Access Compliance Report

Public Rights-of-Way

(Curb Ramps)

Intersection ID: 10140	Main Street: E_36TH_ST	Cross Street: N_ALEXANDER_ST	Location: S
ADA ID: 63C5C35C58E5	Ramp Type: PerpDiag	Initial Pass/Fail: Pass	Overall Compliance: No
Severity Score: 25			
Codes/Mitigation Info/Possible Solution		Field Measurements/Component Compliance

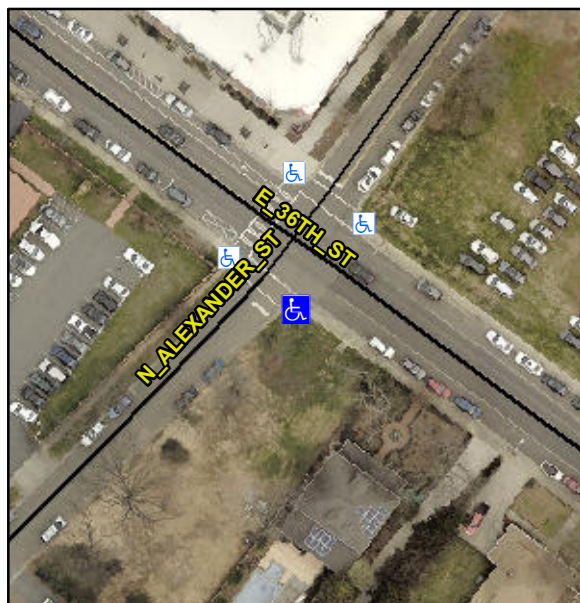
Not Found, R304.2.1, R304.2.2-Perp, R304.3.2-Para, R304.5.3, R305.2, R302.7.2

Remove & Replace Curb Ramp With Two New Directional Ramps or Equivalent.
